**Specialty Home Inspections
Presents**

**A Home Inspection Report On
14234 Reissen Ln., Houston, TX
Sold by Rosalba Cabrera, Listed By**

PROPERTY INSPECTION REPORT

Concerning: 14234 Reissen Ln., Houston, TX 77069
(Address or Other Identification of Inspected Property)

High Soil:

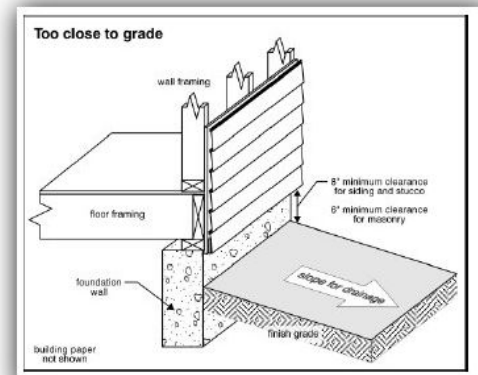
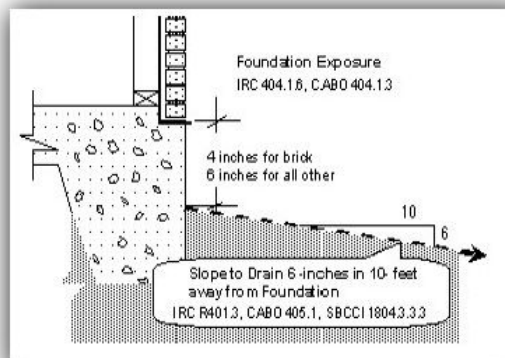
- Various points around the perimeter beam of the foundation the soil is too high, it must be at least six inches from the ground to avoid water intrusion and/or pest infestation.

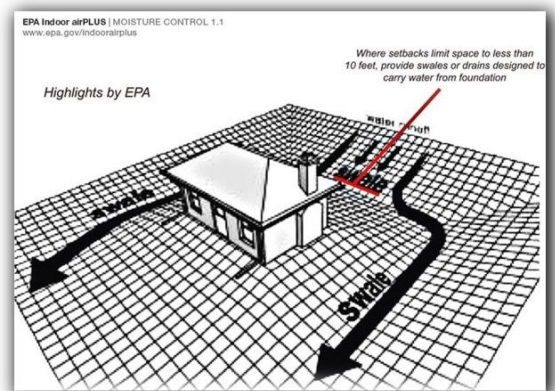
12. Ponding noted at several points around the foundation or near the

foundation all low spots should be filled, compacted and caused to drain away from the foundation to avoid future foundation settlement issues.

Figure 8

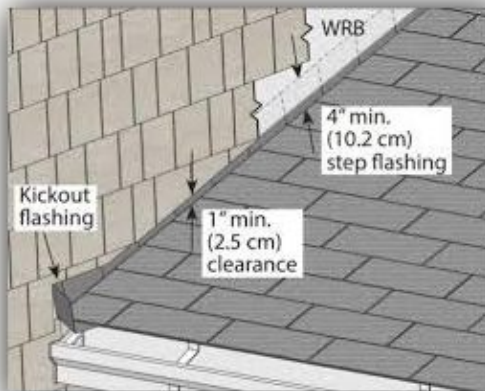
21. Missing a kick out on the flashing by the roof on the front elevation.

Because of the volume of water that can pour down a sloped roof, one of the most critical flashing details occurs where a roof intersects a sidewall. The roof must be flashed with step flashing. Where the roof terminates, install a kickout to deflect water away from the siding (figure 8).

Subject property on the right and it is correct on the left side

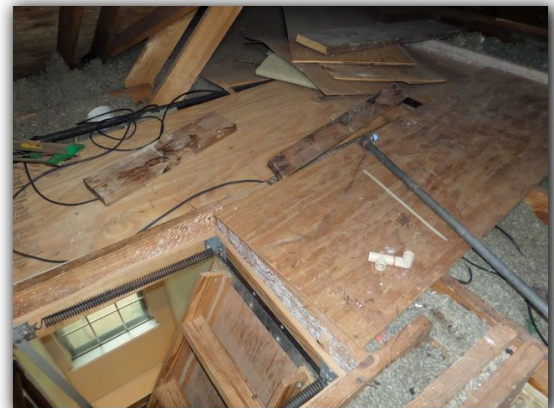
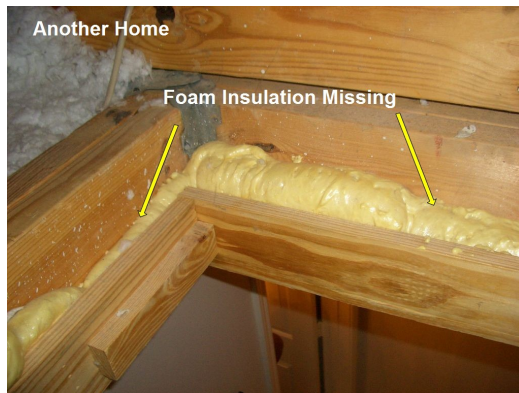
26. The attic ladder is missing insulation as required by code.

27. The attic ladder is missing a weather strip as required by code.

- 28. Missing foam insulation at the perimeter of the attic ladder frame as per code.
- 29. N1102.1.10 Air leakage. All joints, seams, penetrations, window and door assemblies and their respective jambs and framing; and other sources of air leakage (infiltration and exfiltration) through the building thermal envelope shall be caulked, gasketed, weather stripped, wrapped, or otherwise sealed to limit uncontrolled air movement (see photo below)

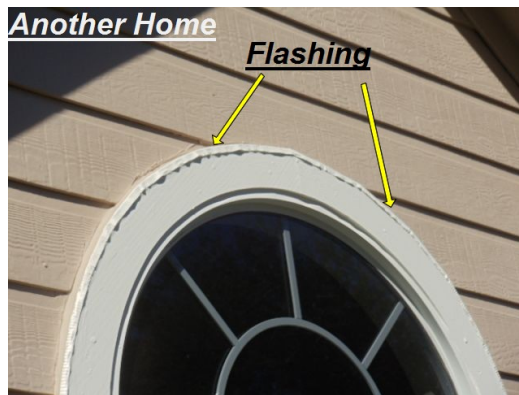
39. Missing metal flashing above arched window trim as per IRC code R-703.8.1.4 & R-703.1

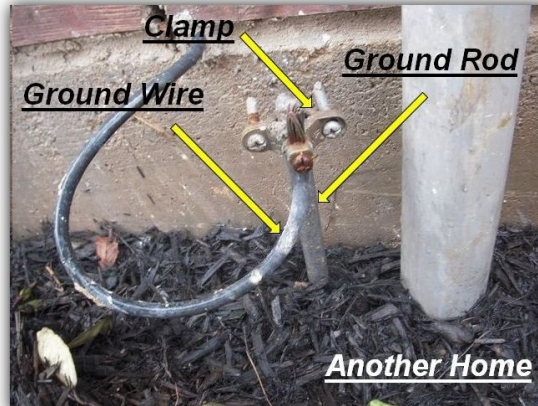
81. Ground rod must be above ground and visible, the ground rod clamp must be visible, the ground rod should extend at least six inches above the ground to be able to inspect and maintain the ground rod clamp, see photo below of another home with a properly installed ground rod.

Labeling of Breakers:

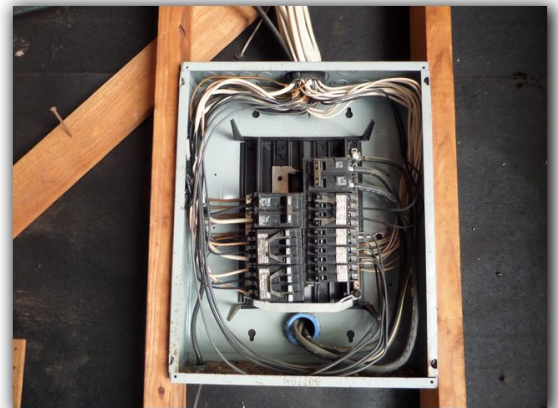
82. Main panel dead front cover is not labeled as per code.

Drip Leg:

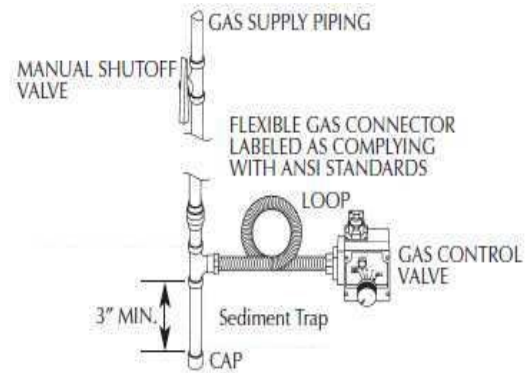
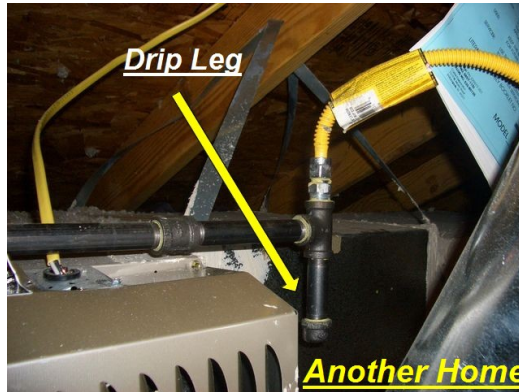
103 Missing a drip leg at the gas connector/gas flex as per code, see photo below of another home with a proper drip leg.

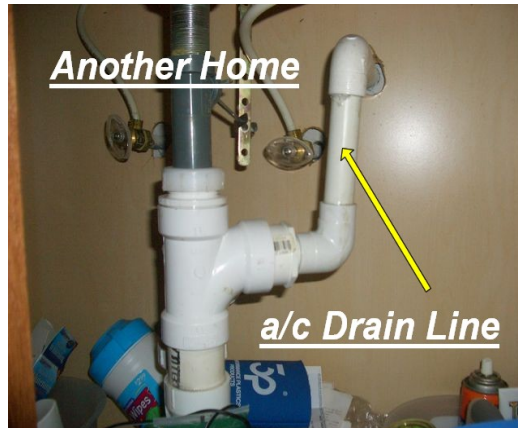
125The primary drain line must be cleared.

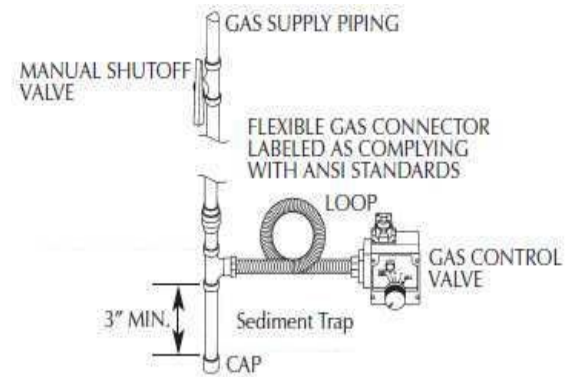
177Missing a drip leg as per code.

Bonding to System:

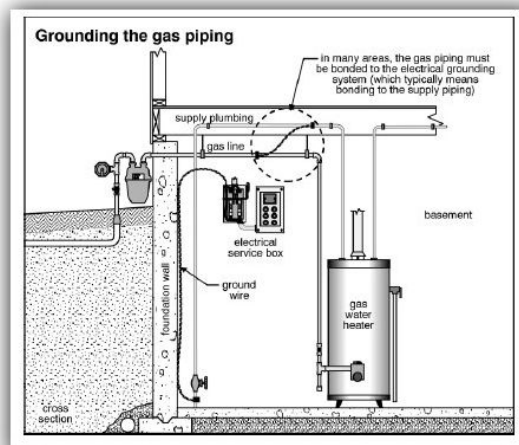
178The hot and cold water lines were not bonded to the gas line as per code

179E3509.6 Metal water piping bonding. The interior metal water piping system shall be bonded to the service equipment enclosure, the grounded conductor at the service, the grounding electrode conductor where of sufficient size, or to the one or more rounding electrodes used. The bonding jumper shall be sized in accordance with Table E3503.1. The points of attachment of the bonding jumper(s) shall be accessible.

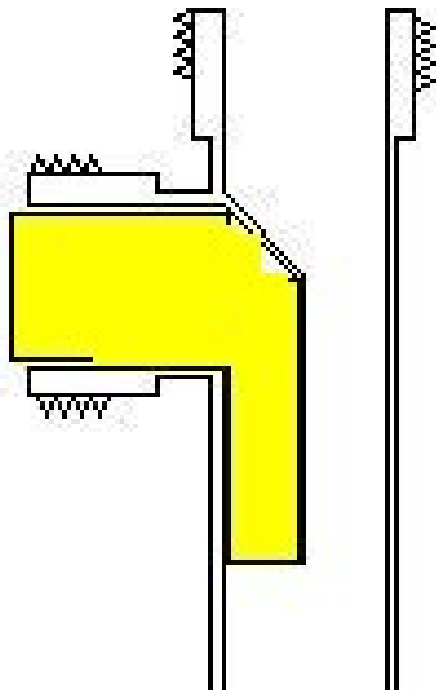
199 This existing drainage arrangement is deficient. As installed the system does not operate as required by code. The problem is with the "end outlet tee", item #2 in the illustration above. Here's what the innards of this part look like:

201Code requires a different type of drain system. The size of the pipe must be consistent thru the entire run and thus with the above diagram it demonstrated that an obstruction or "deflector" when present, it reduces the effective useable radius of the drain pipe, down to 3/4" from the required 1-1/2 inch, a violation of code.

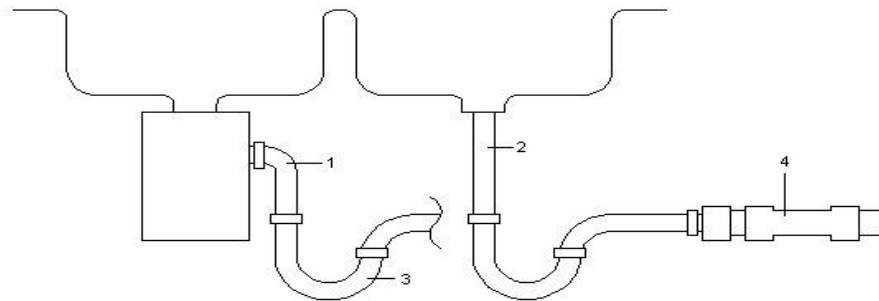
202The solution that is achieved by the method found in the IRC code provides each sink with its own P-trap, then plumb the drain lines together back at the heavier pipe into the wall using a wye connector instead. Wye connectors have big open passages through them. To illustrate:
